Re: Docket LC 78 - In the Matter of Idaho Power Company's 2021 Integrated Resource Plan ("IRP").

**ERRATA TO IDAHO POWER
COMPANY'S REPLY COMMENTS**

Errata Filed: August 16, 2022

1 **Figure 1 Weather-Adjusted Sales by Class to Gross State Product (“GSP”)**

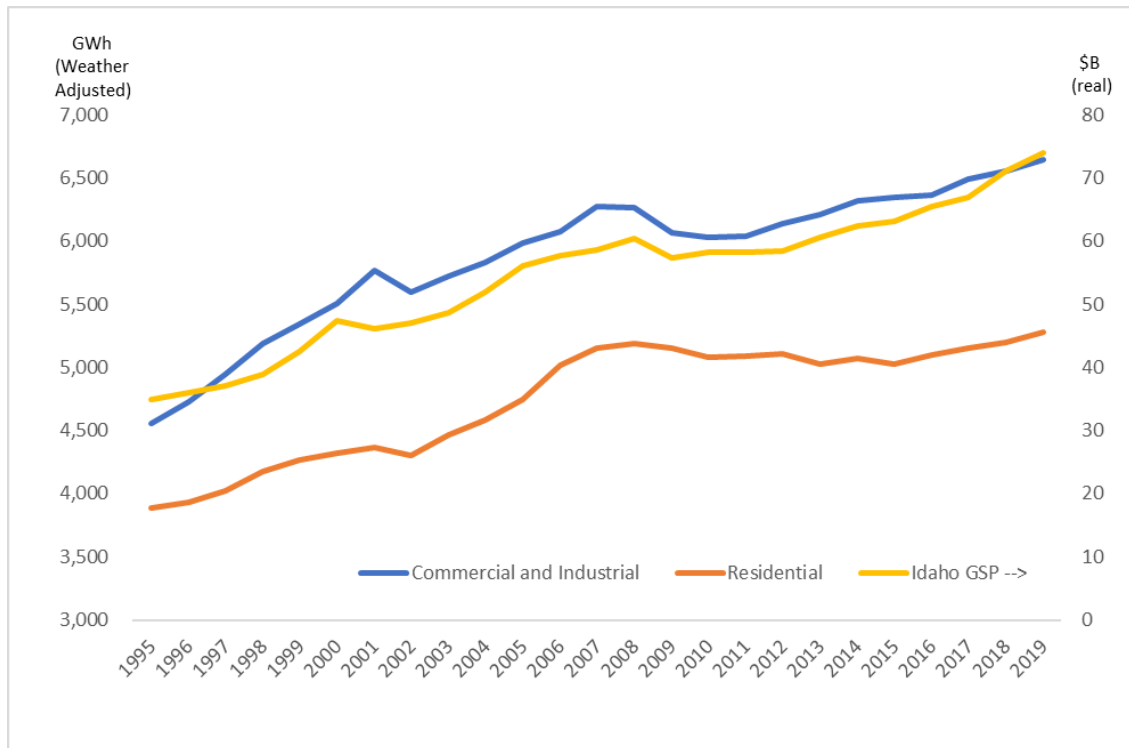
14 With respect to the residential load forecast growth rate, Staff notes that Idaho Power's
15 time series only goes back to 2011.¹⁴ Staff believes this regression model should be tested
16 against longer time periods.¹⁵ Staff's Request for Company Reply Comments 2 and 3 ask the
17 Company to explain how the problem of autocorrelation was resolved in Idaho Power's regression
18 model for residential customers and why the data for residential regression model only goes back
19 to 2011. Further, Staff asks why this same reasoning, of training periods beginning in 2011, does
20 not apply to the regression models with longer time periods of historical data.¹⁶

16 Figure 1 below shows a comparison of Gross State Product for Idaho and the annual
17 weather-adjusted energy sales for residential and commercial and industrial sectors. Starting in
18 2011, growth in the economic output for the state continues to show a strong correlation with the
19 commercial and industrial sectors, whereas a shift in the correlation appears to exist for the
20 residential sector.

1 these structural changes since 2011 are significantly incongruent with the residential model
 2 construct and could potentially lead toward over forecasting bias, further suggesting that using
 3 data from 2011 is appropriate for the residential framework.

7 **Figure 2 Mid-C Hub Average Forward Prices \$/MWh vs AURORA Planning Conditions**

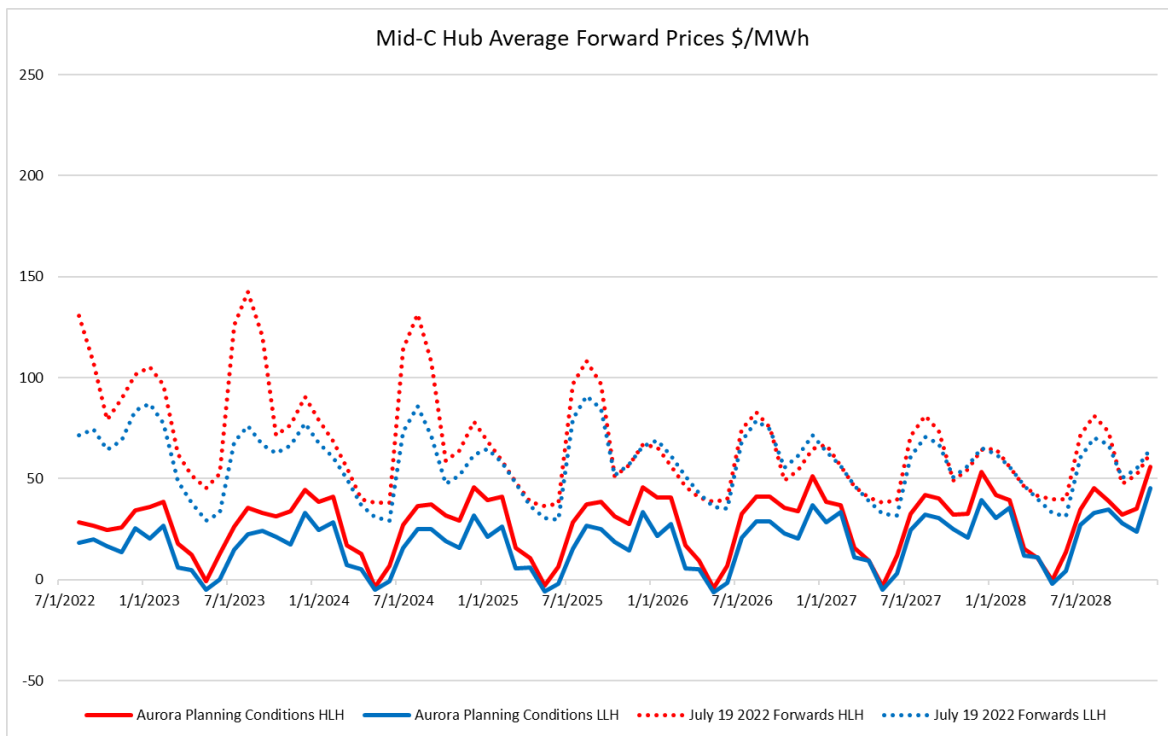
19 Because Idaho Power’s AURORA-based Mid-C forecast is significantly lower than the
20 prices the Company uses to set Public Utility Regulatory Policies Act (“PURPA”) prices in
21 UM 1730,⁶⁸ Staff’s Request for Company Reply Comments 14 is for the Company to graph the
22 2021 IRP’s Mid-C and Palo Verde forecasts with the latest forward price curves of these markets

3 Forward price curves are ever evolving and, as such, today's observable forward market
4 prices were not available at the time the 2021 IRP was developed. Nevertheless, Figures 2 and
5 3 show the latest price curves (circa July 19, 2022) graphed against the planning condition prices
6 from the AURORA model for Mid-C and Palo Verde.
